#### PLANNING AND ZONING COMMISSION ACTION ITEM STAFF SUMMARY JUNE 1, 2022 PLANNING AND ZONING COMMISSION MEETING

Consideration of Resolution No. PZ 02-22, Series of 2022. **(PUBLIC HEARING)**A RESOLUTION APPROVING A LEVEL III DEVELOPMENT PERMIT FOR A NEW DECK ON A COMMERCIAL BUILDING LOCATED AT 765 W. ANEMONE TRAIL.

# SNARF'S SANDWICHES

PLANNING COMMISSION SET 03 MAY 2022

SITE PLAN

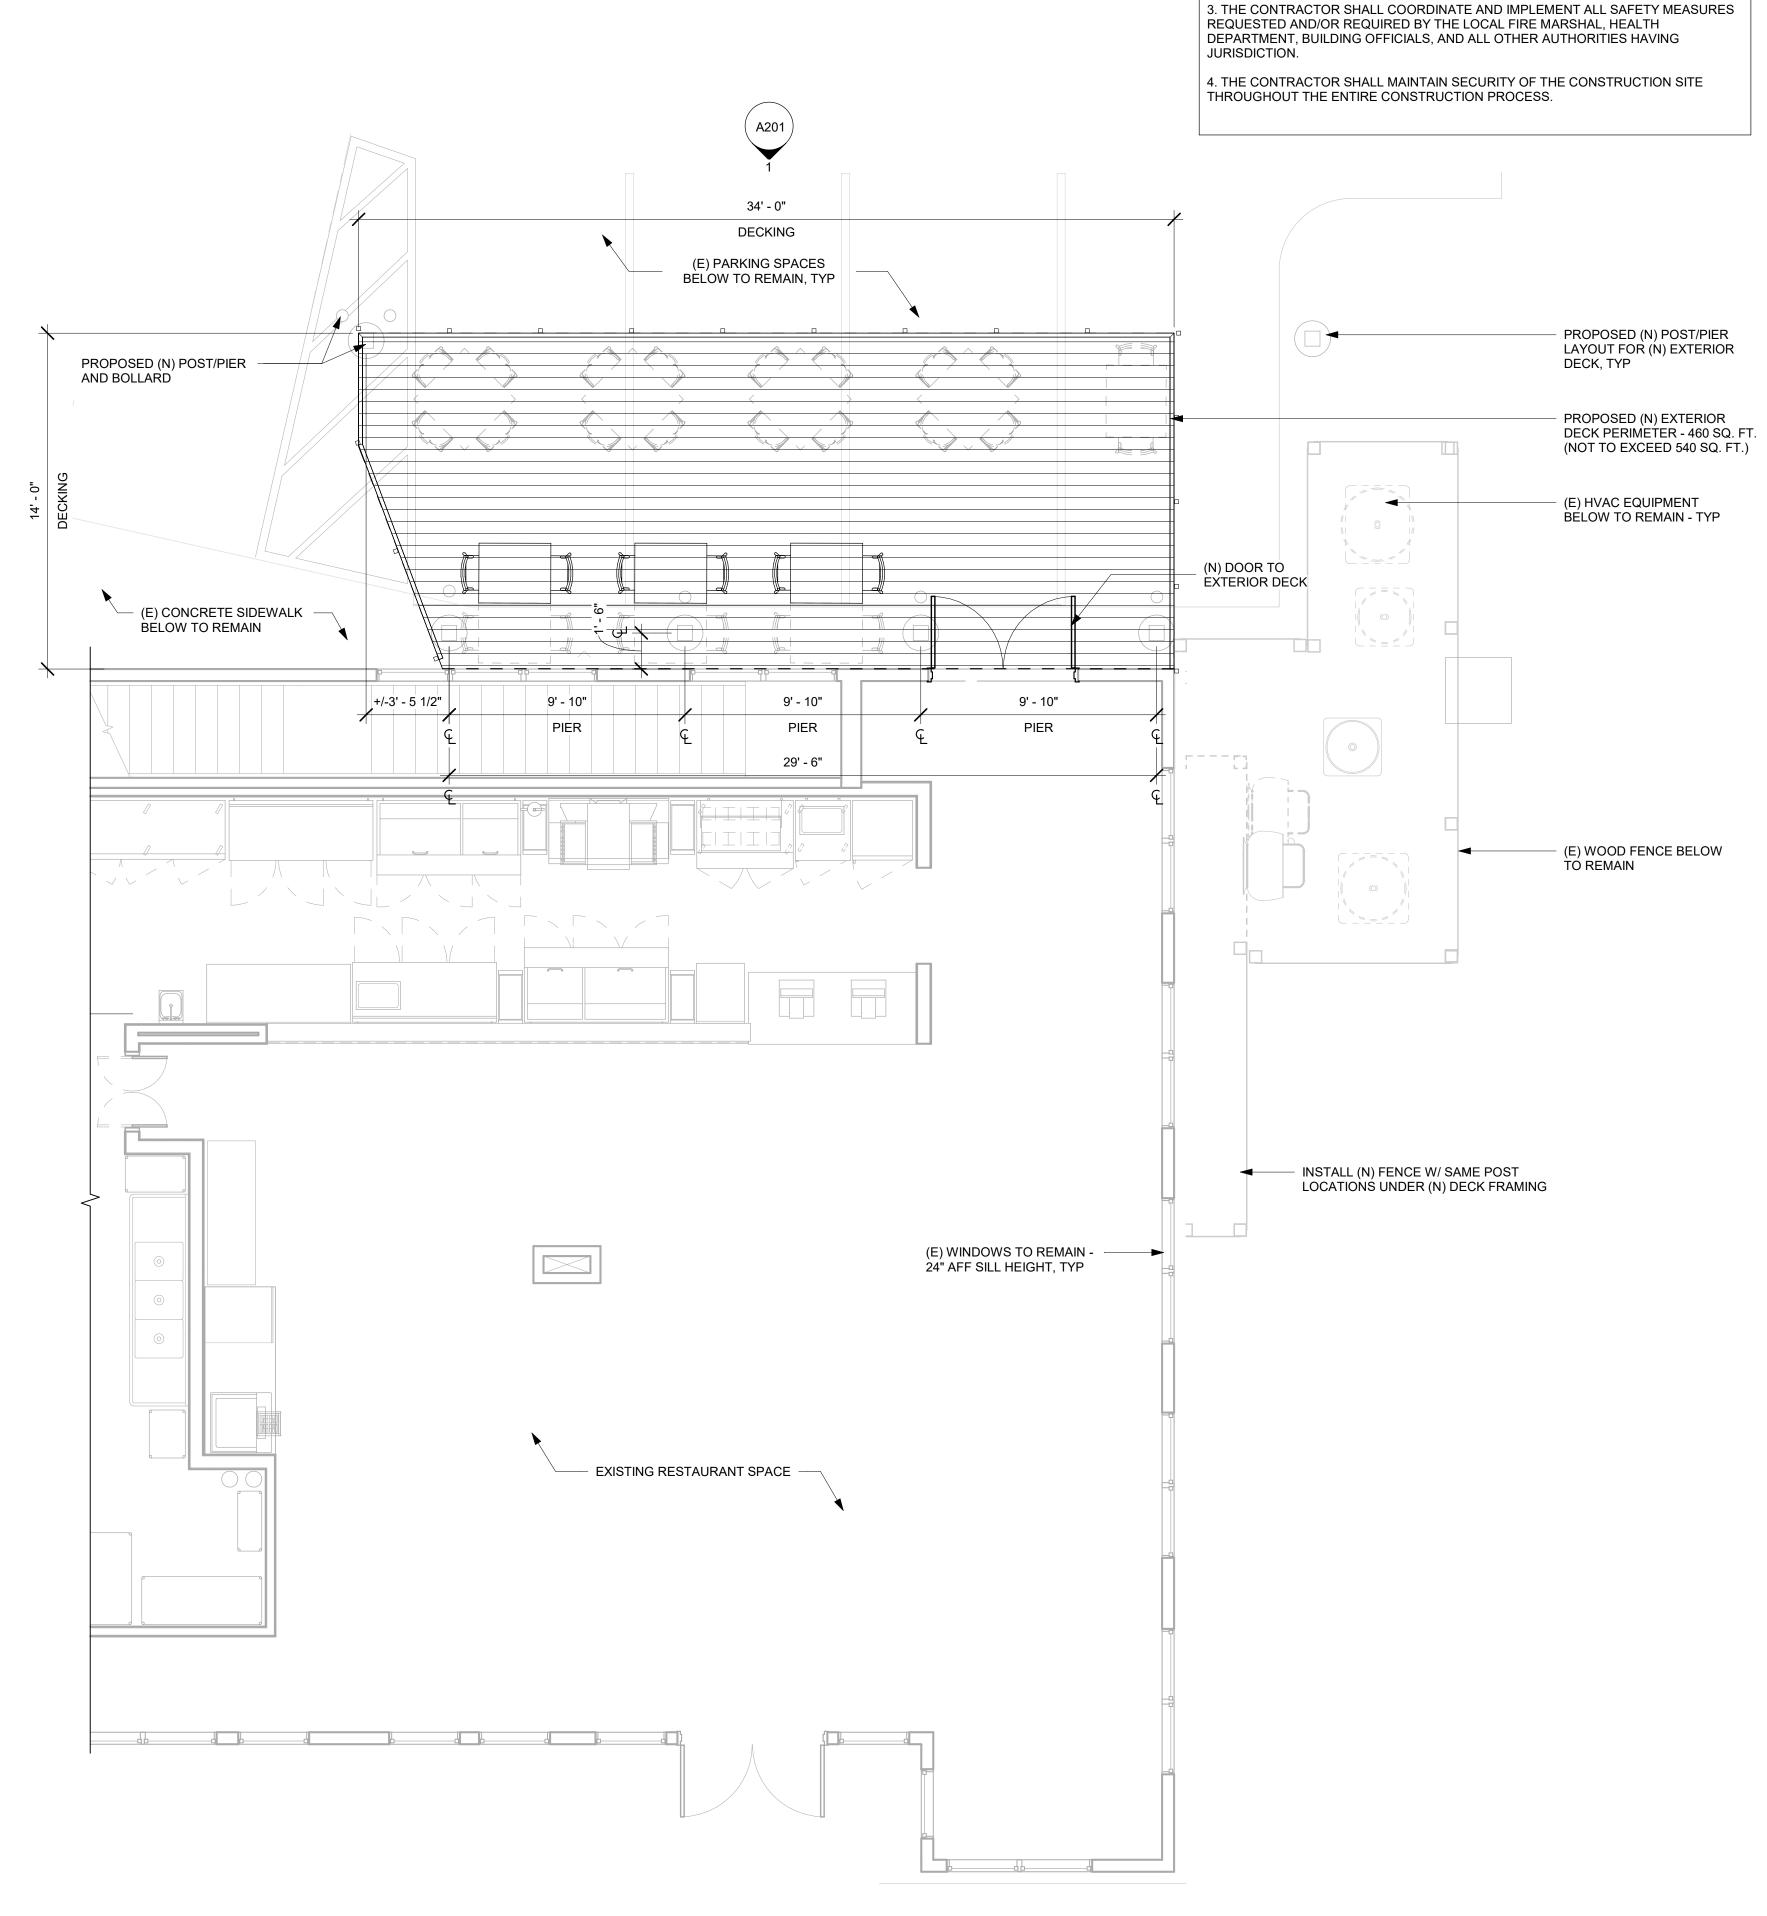
- 1. The Proposed deck support caisson / foundation is located twenty (20) feet from the northern property line as shown on page A100 of the plans dated May 3, 2022.
